Addendum #2

RE: Bock Park Phase One

This addendum forms part of the Contract Documents and modifies the original Bidding Documents as noted below. Acknowledge receipt of this addendum in the space provided on the Bid Form. Failure to do so may subject Bidder to disqualification. This addendum is (7) total pages and includes this (2) page memo, (5) revised drawing sheets which consist of the following changes.

C3.1

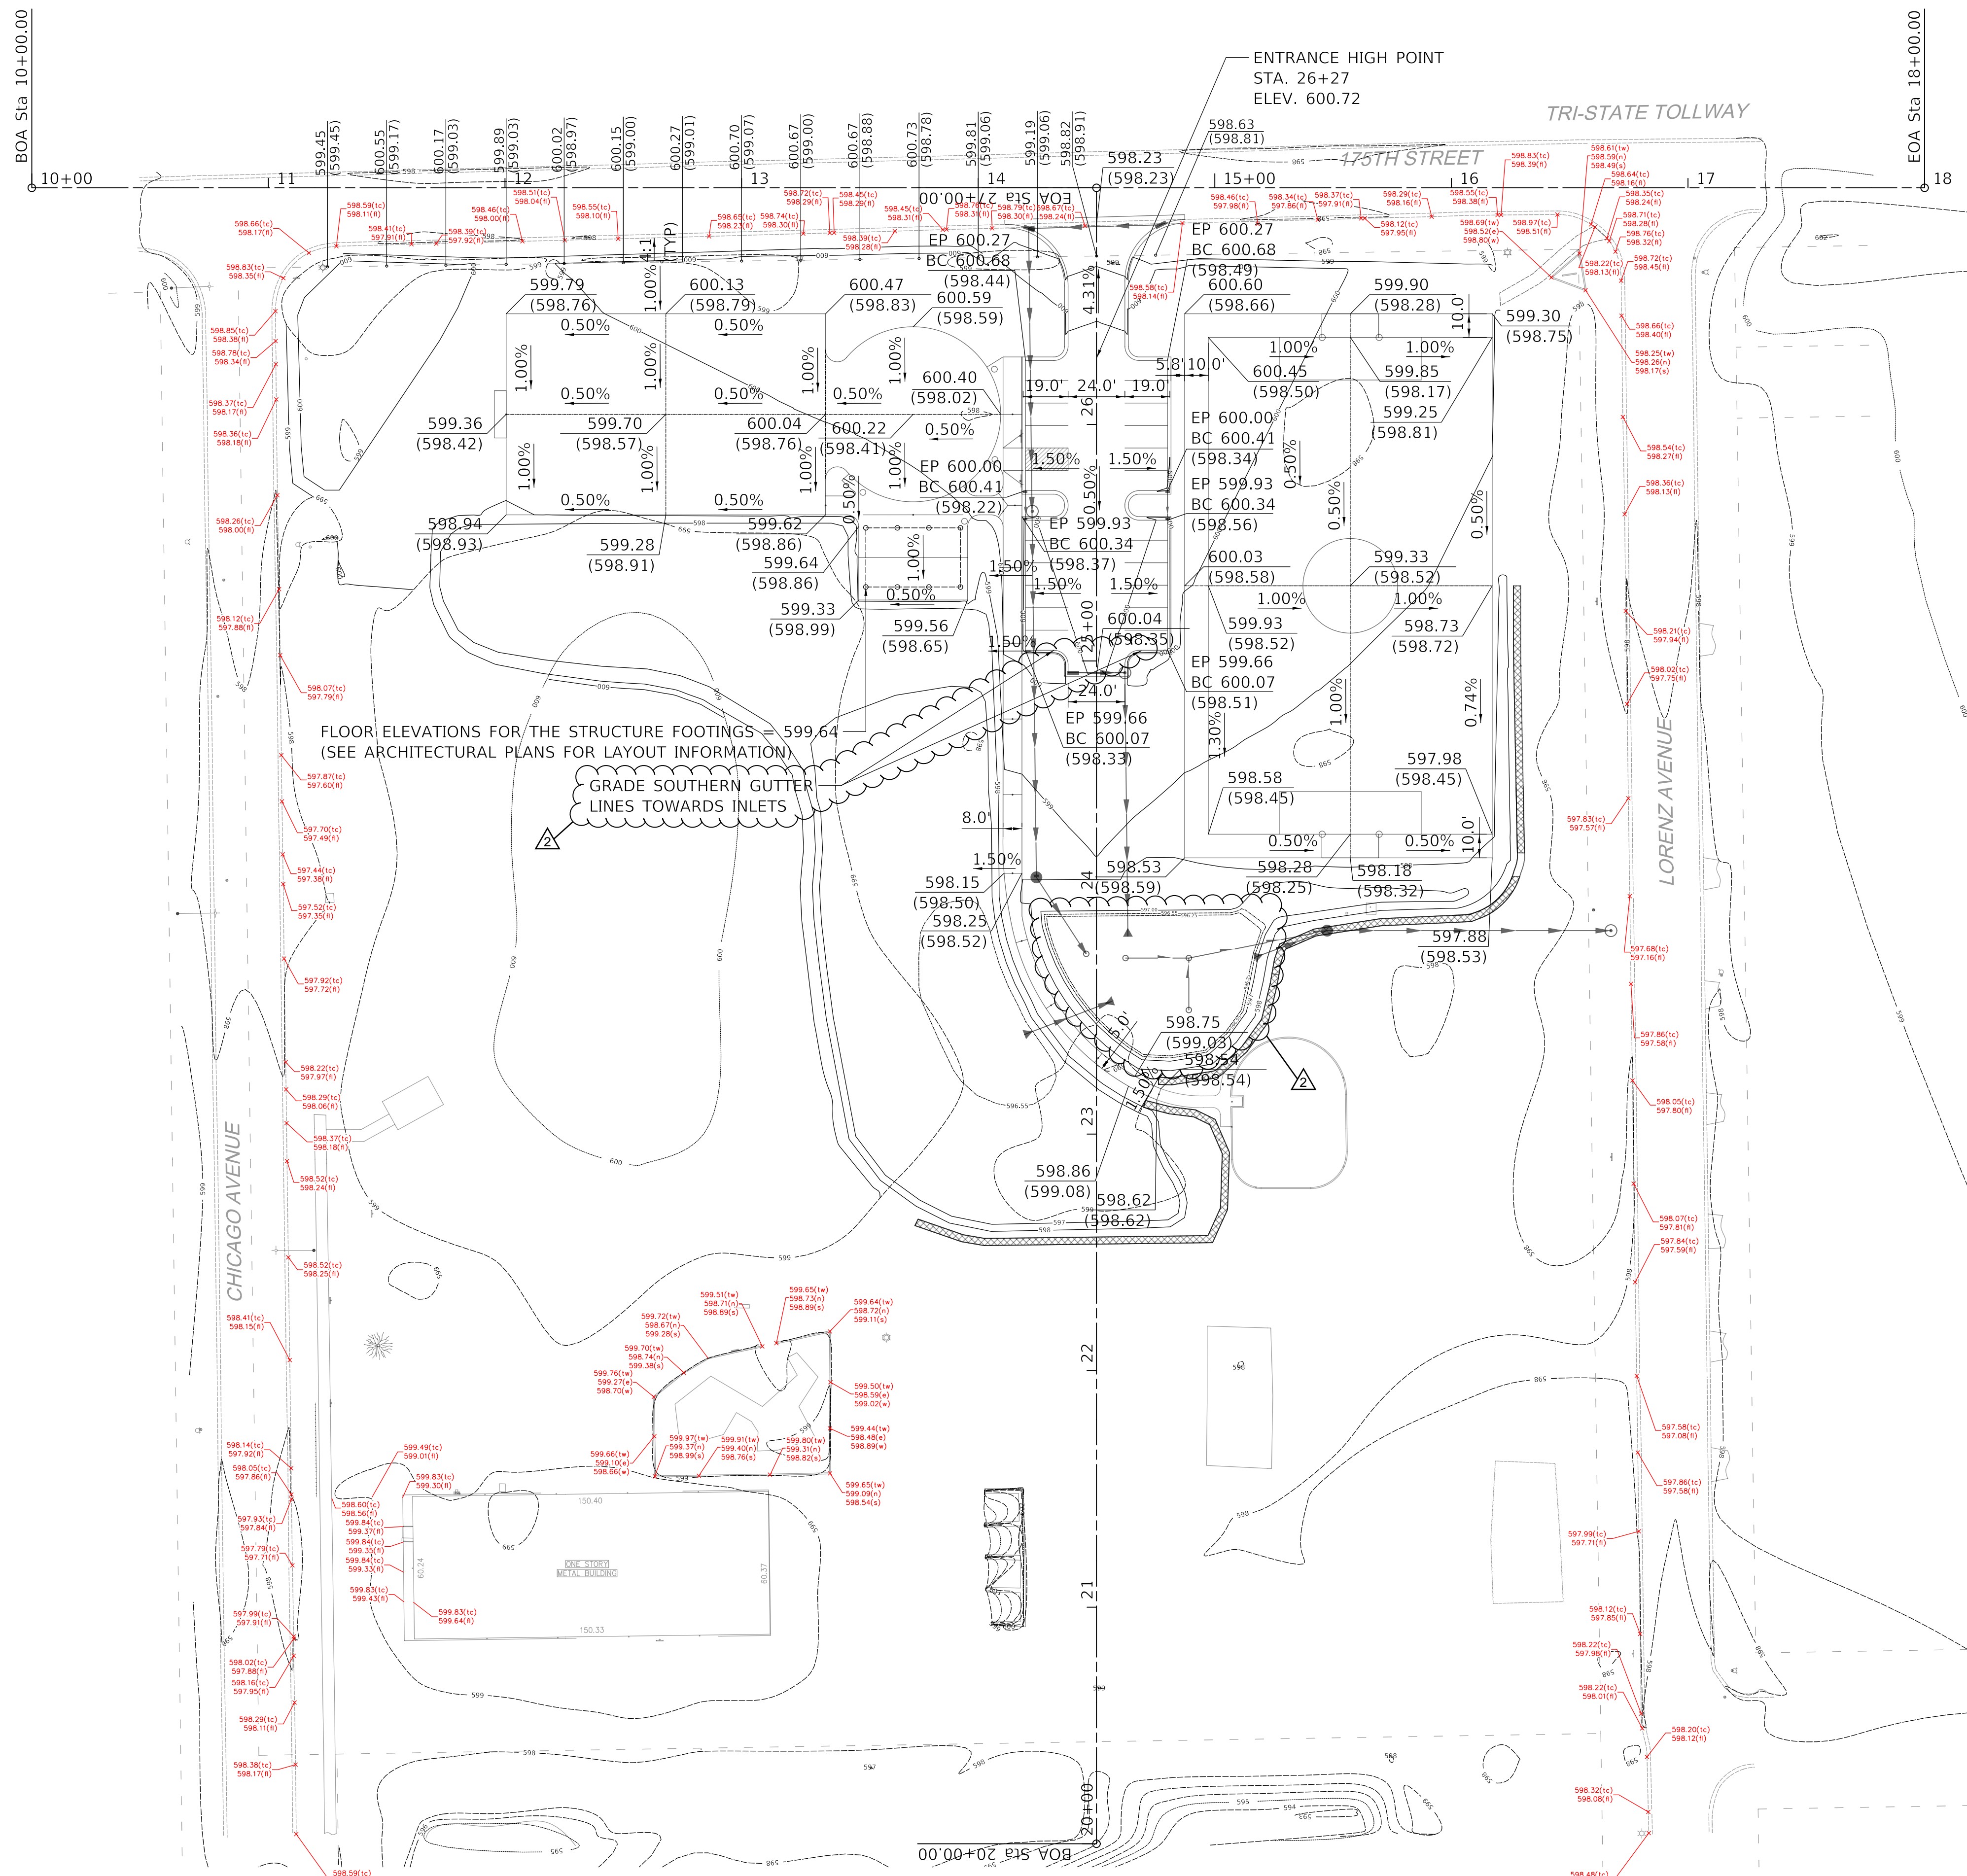
- Replace Sheet C3.1 – Grading Plan:
 - Providing updated southern gutter drainage information

- *Sheets C1.1, C2.1, and C3.1: proposed contours in the east BMP cell have been revised to only include the finished grade contours.*
 - *Sheet C1.1 and C2.1: proposed and existing intermediate/index contour lines added to legend.*

TECHNICAL GUIDANCE MANUAL
 BIORETENTION FACILITY DETAIL

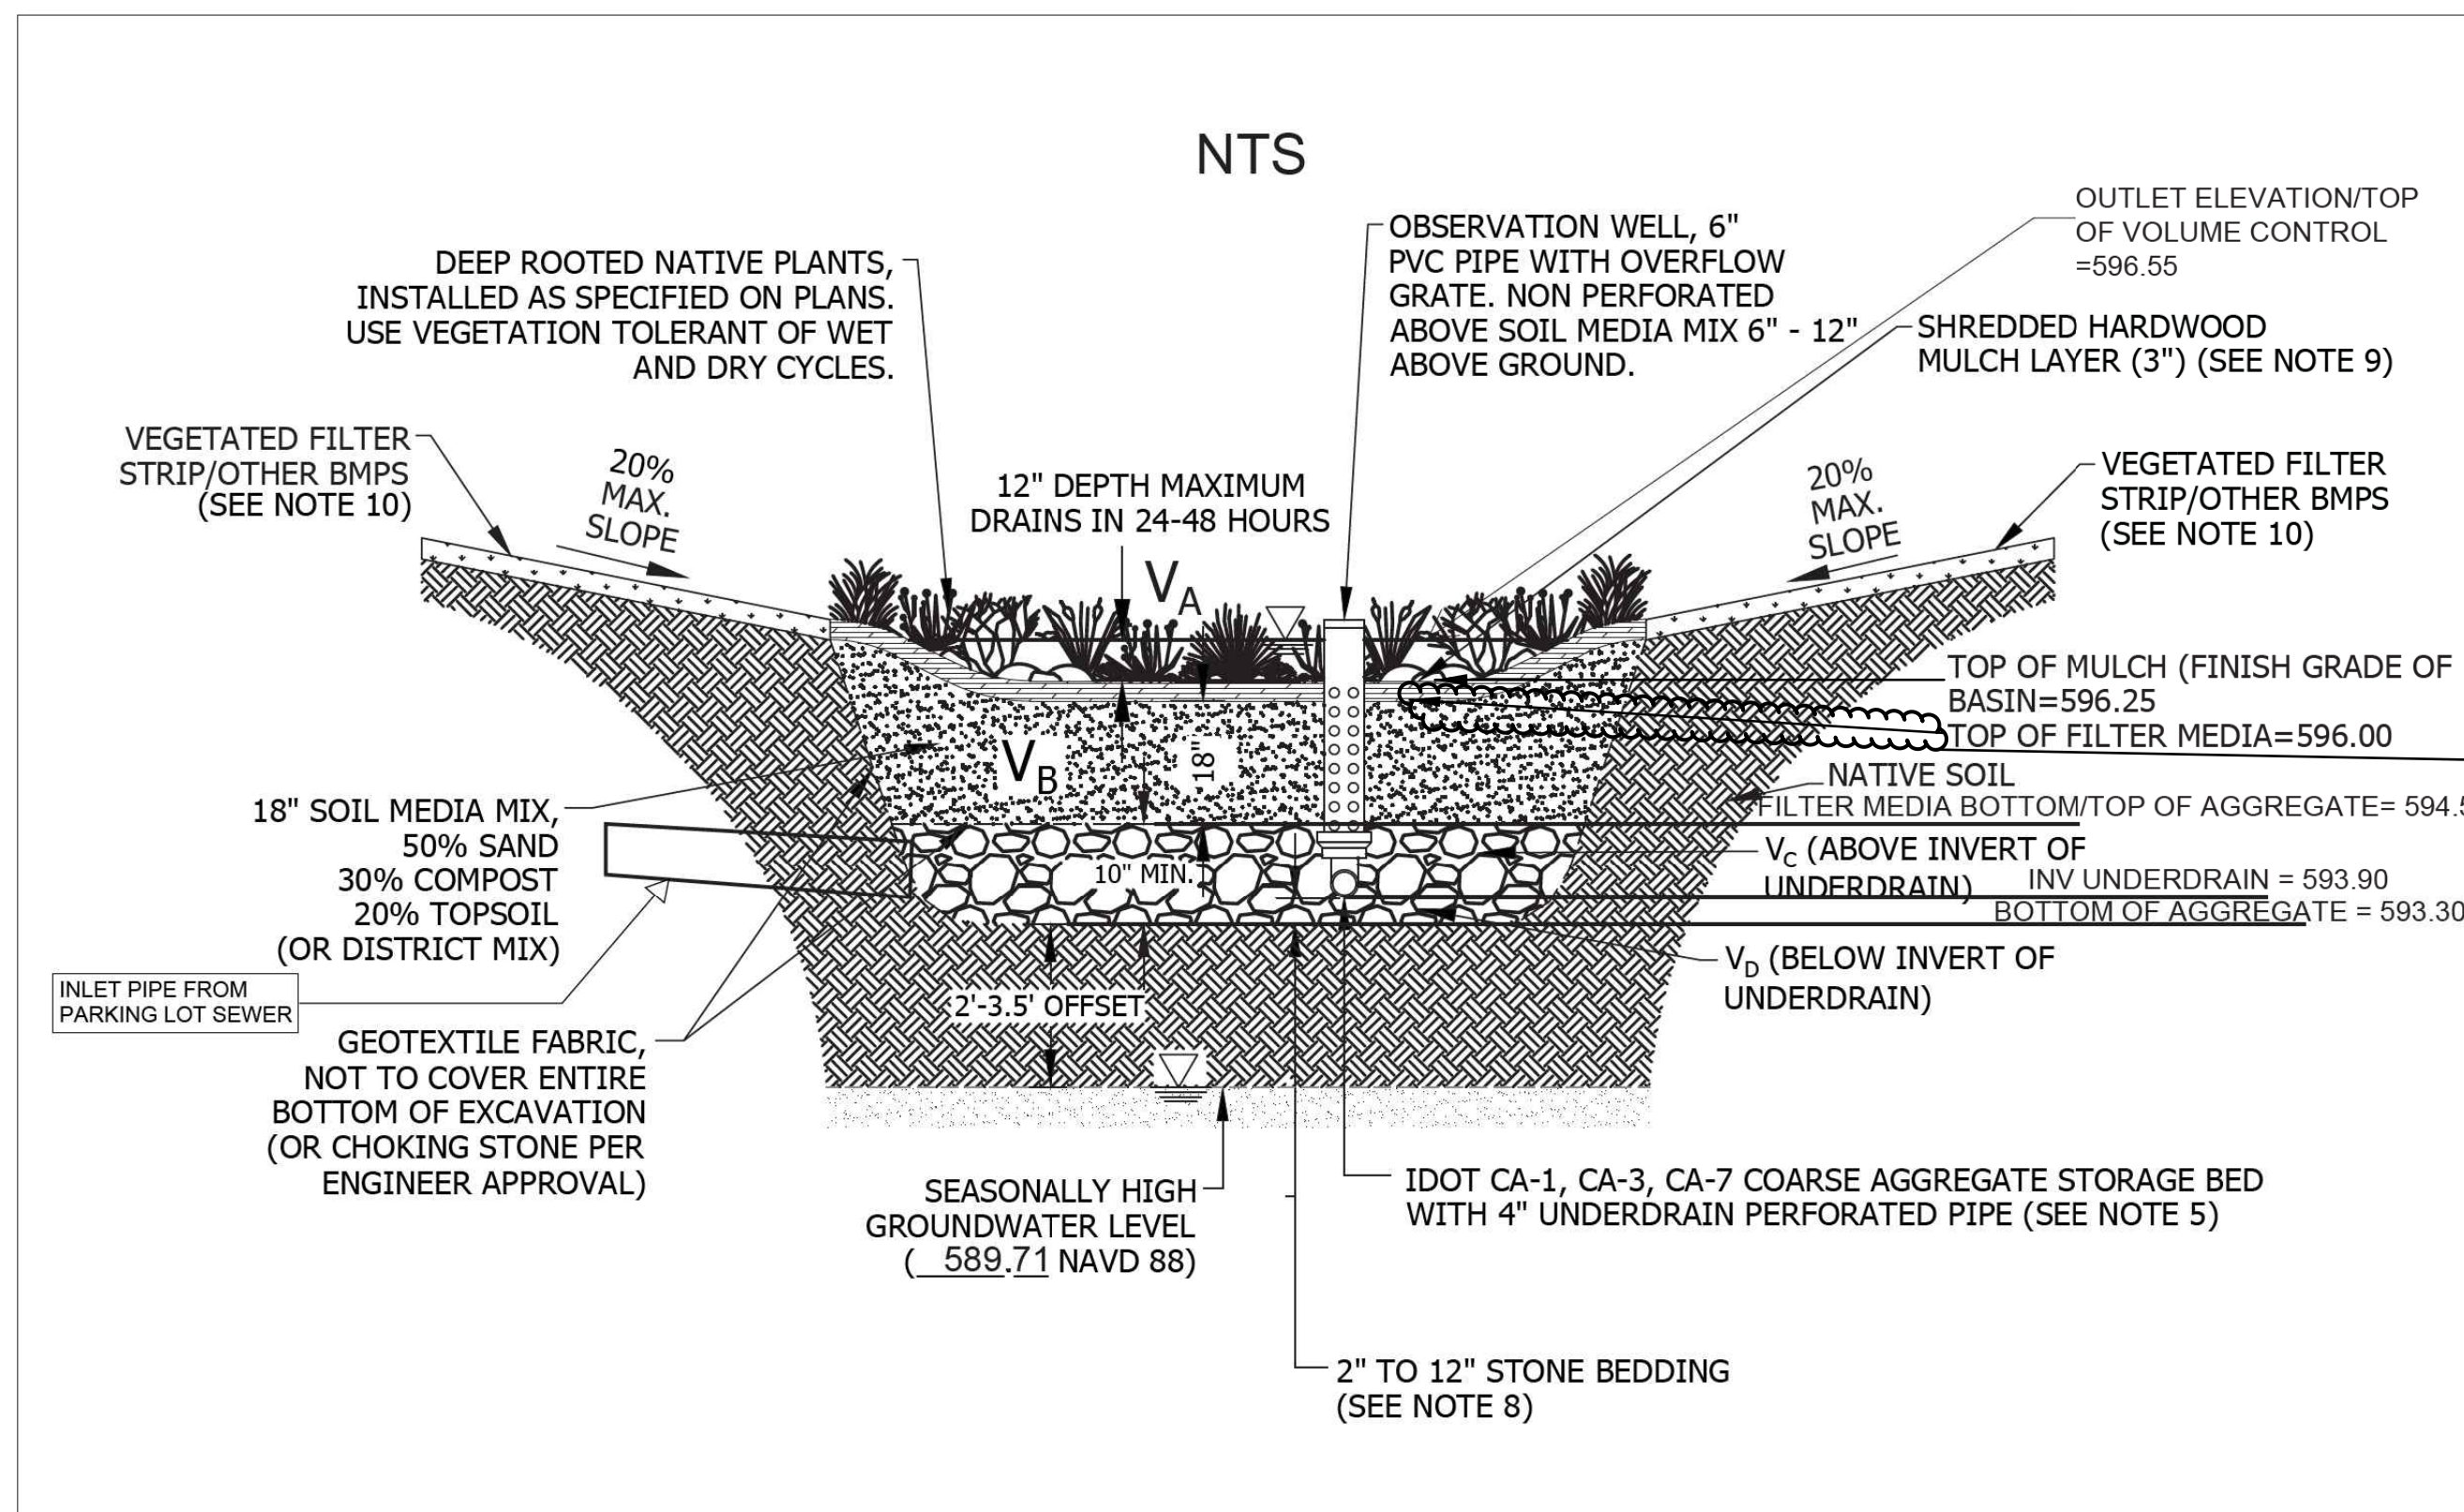
- Replace Sheet C4.2 – Details:
 - Bioretention detail has been updated

- *Sheet C4.2: arrow added to the detail to clarify the top of filter media elevation.*
- **Question:** The rim elevations of the catch basin and manhole at the south edge of the parking lot (18 & 19) are 599.86, while the southeast and southwest corners have an EP grade of 599.66. Confirm how water will flow from these corners to the south structures. It appears there is a low spot at the corners.
